## **RFQ AMENDMENT #1**

***EXHIBIT DESIGN/BUILD***

***NATCHEZ TRIBAL HISTORY CENTER***

Questions and Answers

1 FLOOR PLAN OVERALL  
A100 1/16" = 1'-0"

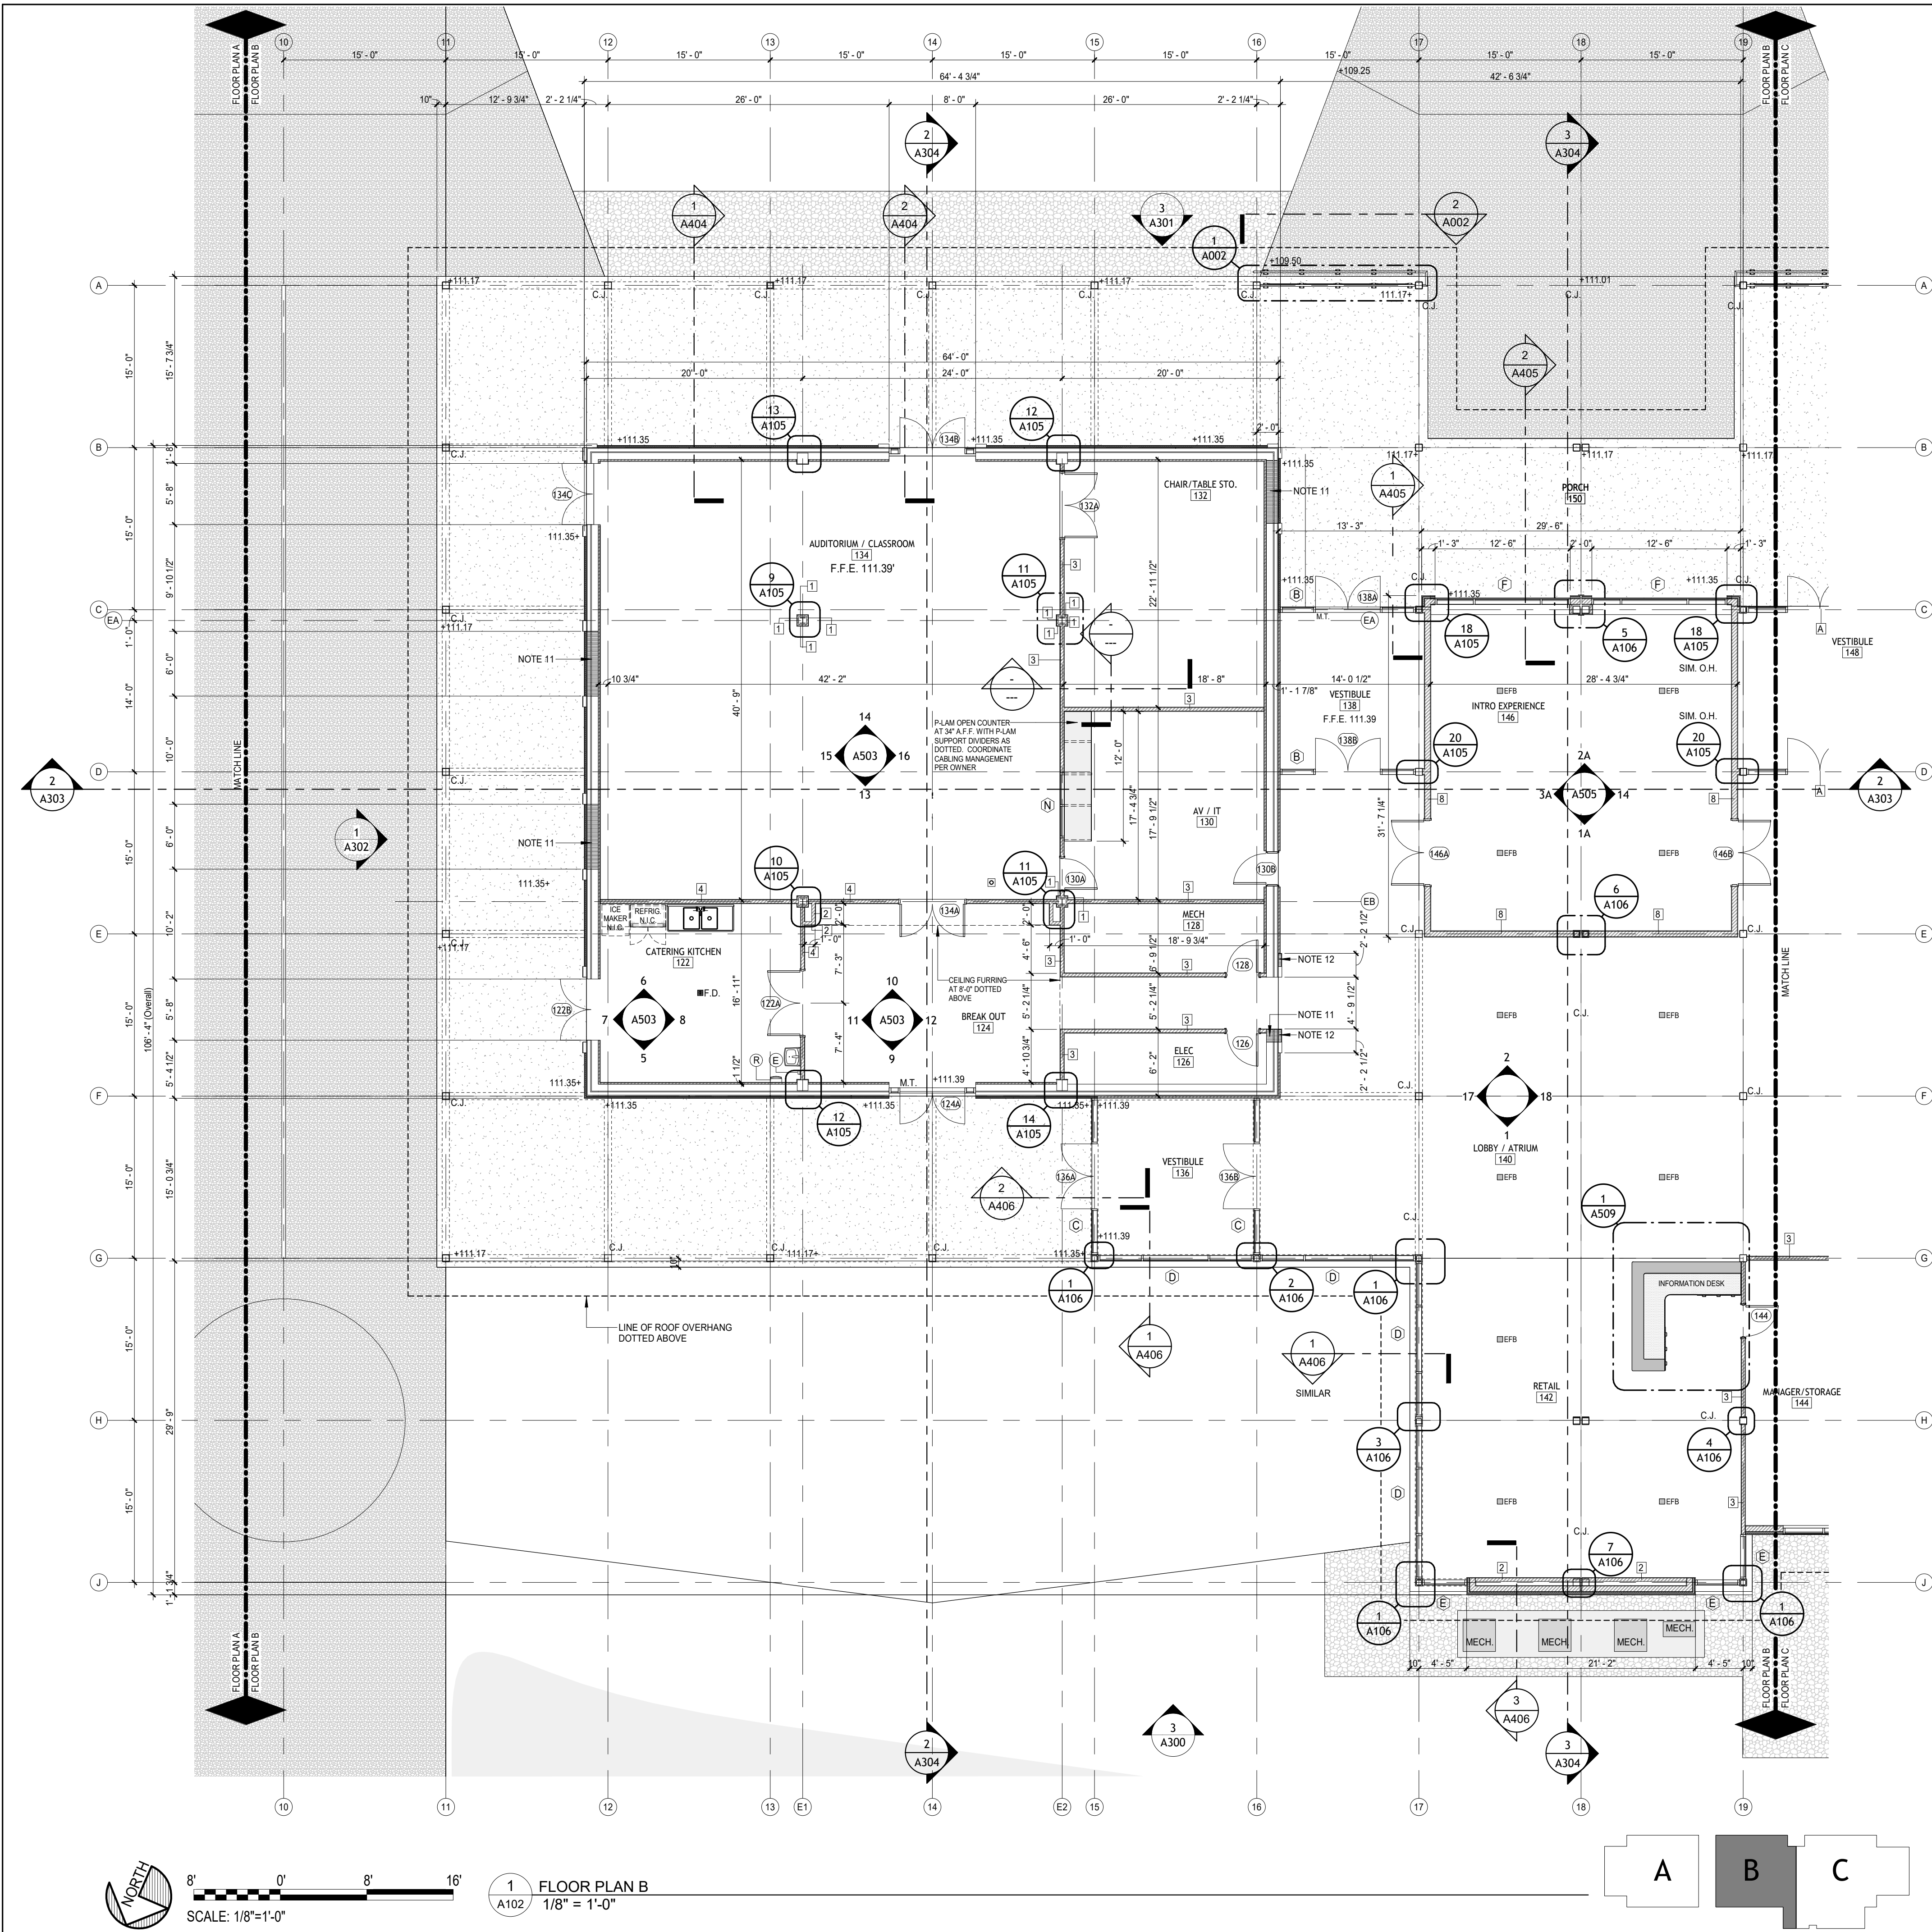
126	Would you be willing to share floor plans of the exhibit space and introductory media space?	Yes. See attachment.
127	Is there a specific date (or season) in 2027 that you'd like to open? What is the anticipated date for occupancy and completion of the building?	The new facility is anticipated to be open to the public in late 2027. There is no set date.
128	Are you looking for a particular cost savings from your \$3.5 million allowance?	No. We are looking for a proposal that meets the criteria set forth in the RFQ document.
129	How would you qualify the scope of digital engagement you want to see in the museum?	Digital engagement should be present in the exhibit gallery. MDAH is open to contracted firm's suggestions.
130	How would you qualify the amount of immersion in digital/large format digital environments you would like to see in the museum?	MDAH is open to contracted firm's suggestions.

164	What are the expectations for meetings and presentations (virtual/remote, cadence of meetings/workshops)?	Offerors should plan for at least one in-person meeting per phase, with the majority of meetings and presentations being virtual.
165	Shall we account for any on-site meetings/work sessions?	Offerors should plan for at least one in-person meeting.
166	Are there existing projects with elements that you're interested in, as precedents?	The exhibits at the Choctaw Cultural Center in Durant, OK, and the exterior spaces at the Chickasaw Cultural Center in Sulphur, OK are exceptional experiences.
167	Are there existing projects that demonstrate elements you'd like to avoid?	No
168	Do you envision this exhibit being "high tech", "low tech", or somewhere in the middle?	MDAH is open to contracted firm's suggestions.
169	Are there technologies you'd like to be sure to include or avoid?	No
170	Can a building and site plan be provided?	Yes. See attachment.
